Council Bill: B 285-13

Re: CVS rezoning and development plan approval - supplemental information (Case #13-127)(B285-13)

A request by Mark Stevenson, Trustee of the Mary M. Hackett Trust No. 1, and Roth Properties, LLP (owners) to rezone approximately 1.39 acres of land on the southeast corner of Providence Road and Broadway from C-2 (Central Business District) and M-1 (General Industrial District) to C-P (Planned Business District), and for the approval of a C-P development plan to be known as "CVS C-P Development Plan". (Case #13-127)

**AGENDA REPORT
PLANNING AND ZONING COMMISSION
September 19, 2013**

CVS C-P DEVELOPMENT PLAN

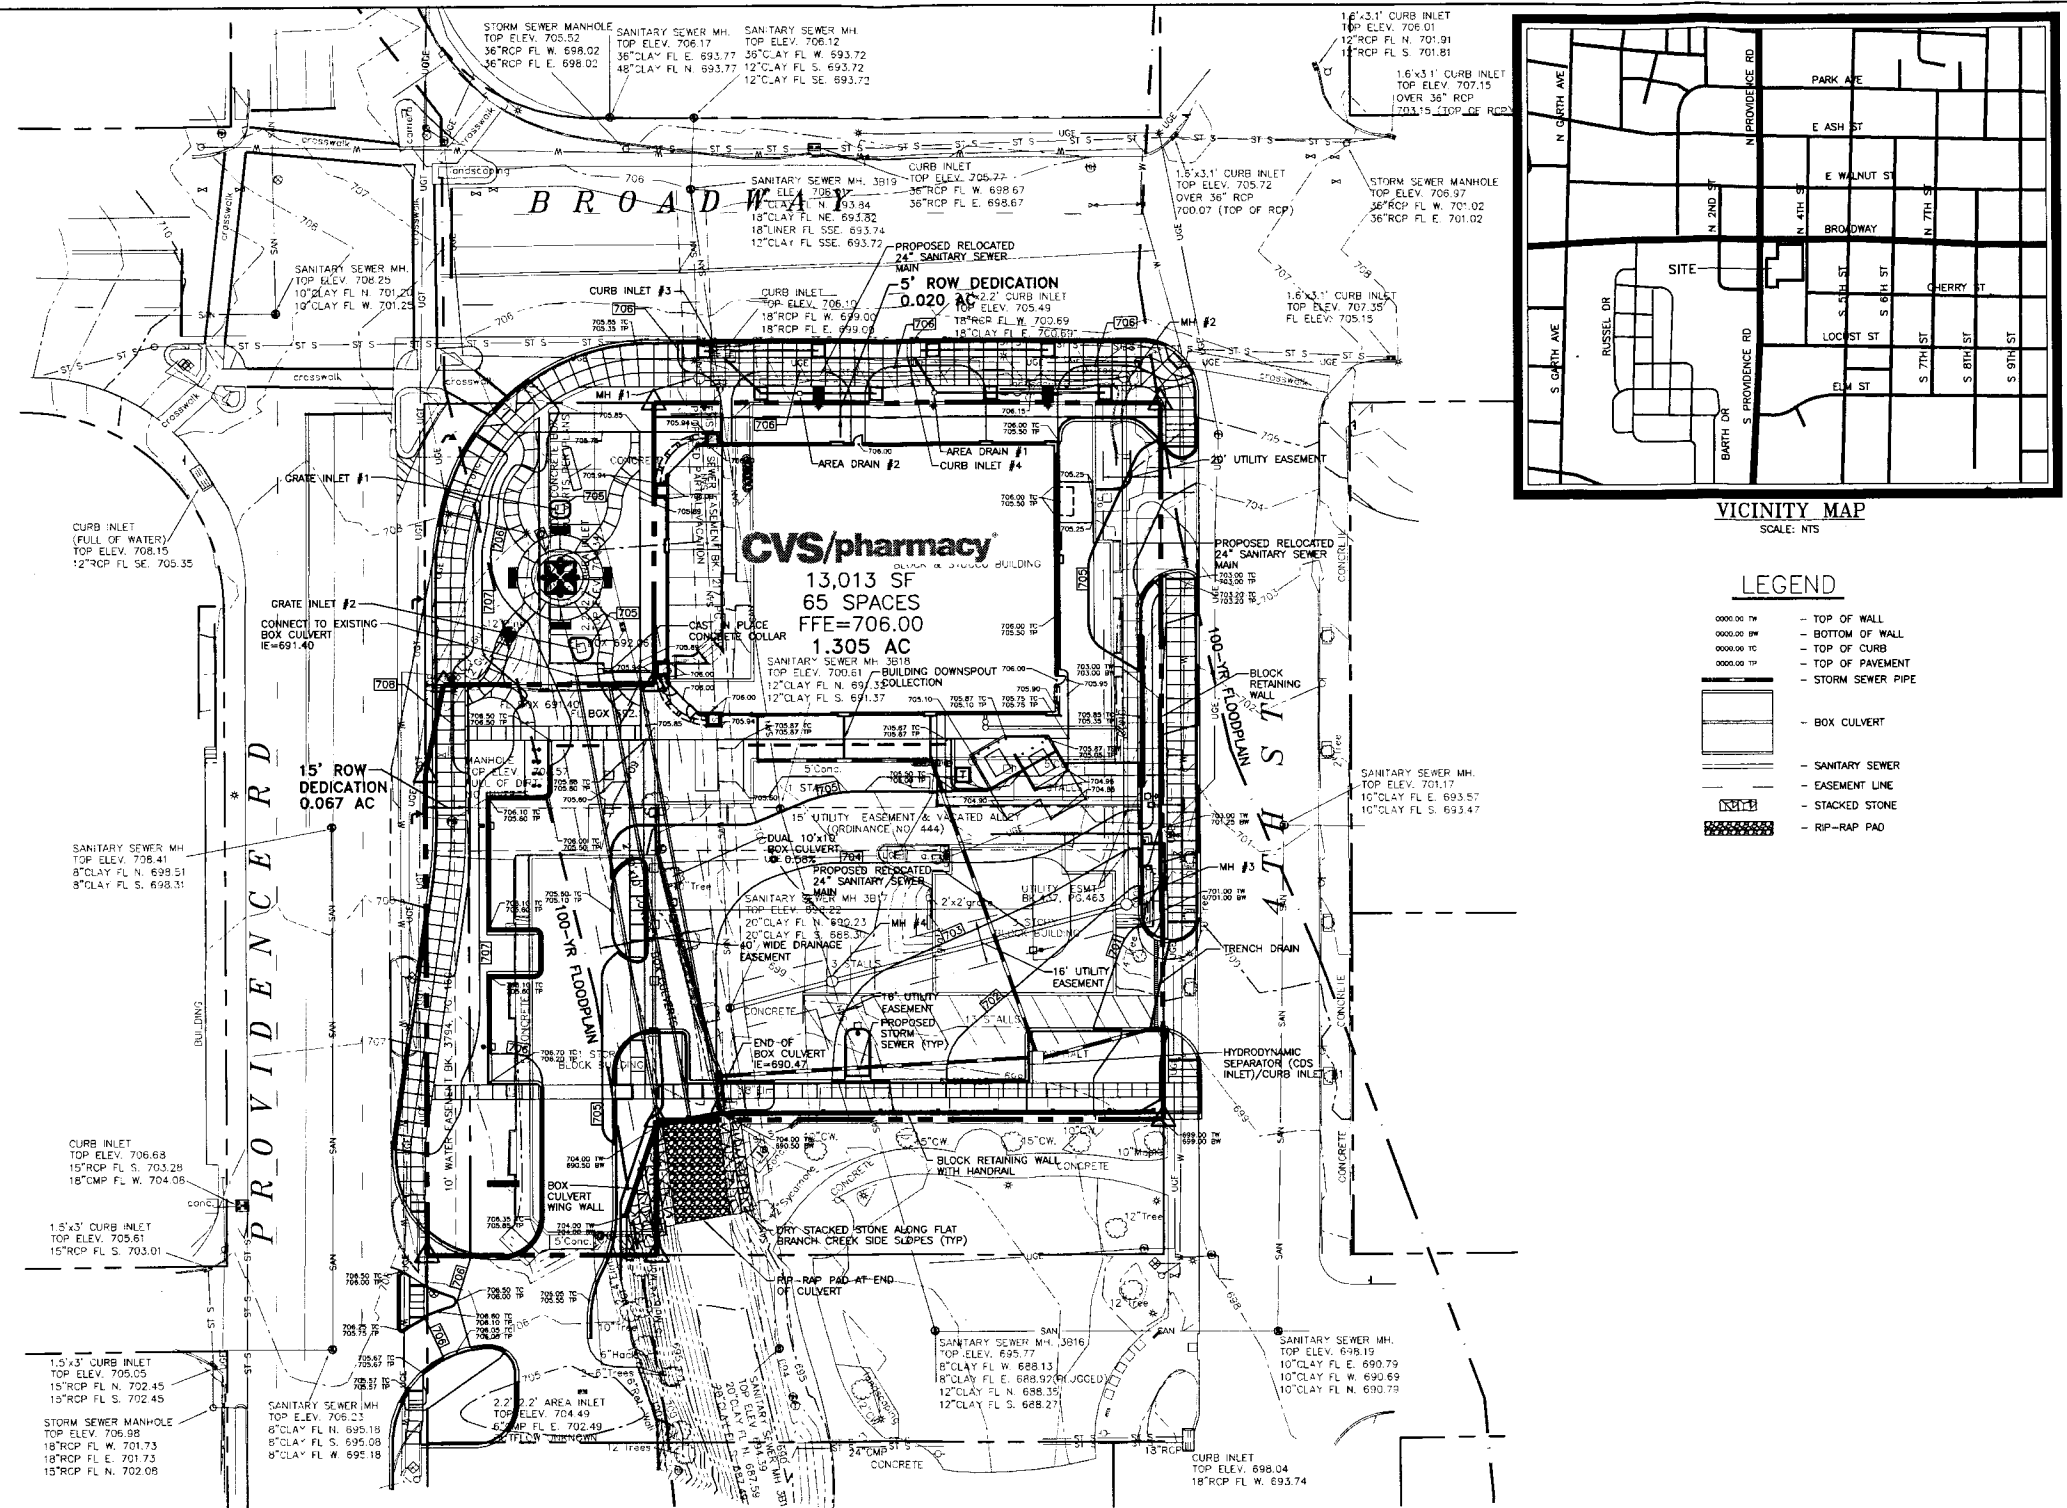
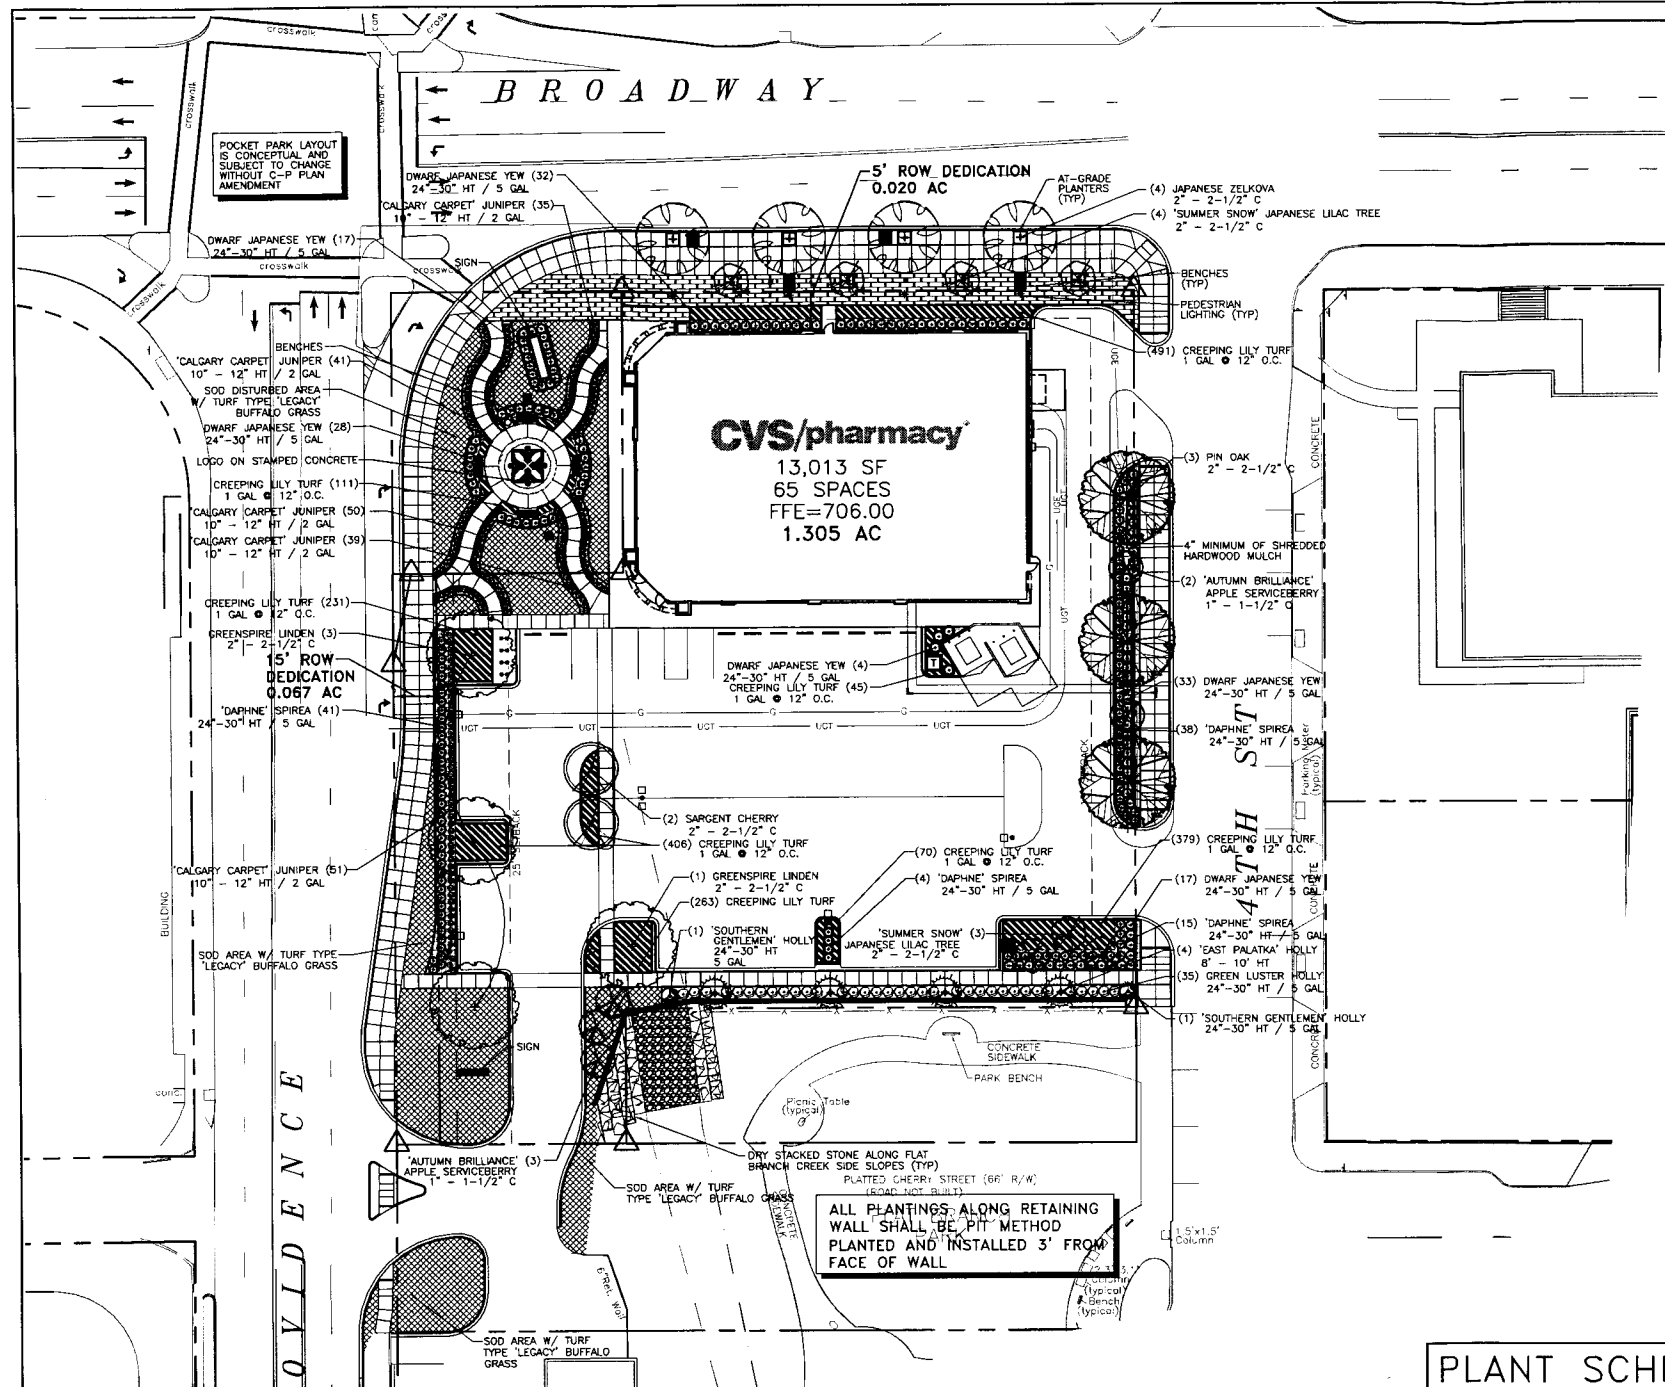
While provided on the revised site plan, items #3 and #4 do not adequately address the Planning Commission's conditions for approval. The Commission specifically requested additional landscaping be added along the southern property line to "screen" the parking lot and lighting from Flat Branch Park. The proposed landscaping shown will have little effect in doing so based on its proposed planting height and mixture. The majority of the southern property line is proposed to be planted with materials 24-30 inches in height. Additionally, the Commission requested all parking lot lighting be reduced to 16-feet throughout the site. 20-foot lighting has been maintained throughout the parking lot with the exception of a single 16-foot light adjacent to Flat Branch Park.

Furthermore, the site plan now shows a private sidewalk encroaching approximately 3-feet into the City's property at the corner of Providence Road and East Broadway (i.e. the future pocket park). This sidewalk was previously accommodated on private property, but is now encroaching due to the building being shifted westward to accommodate the "right-out" only for the pharmacy drive-thru. There is no apparent public benefit associated with this sidewalk since the entrance to the building is located at its southwest corner. Access to the entrance of the building can be obtained from the corner of Providence and East Broadway through the pocket park. Elimination of this segment of sidewalk would increase green space and reduce impervious surfaces.

7. The sidewalk apron immediately adjacent to the building on the west side is not approved and shall not be constructed by the Developer. A revised Development Plan removing such sidewalk apron shall be submitted by Developer to the Director of Community Development for approval as a minor adjustment.
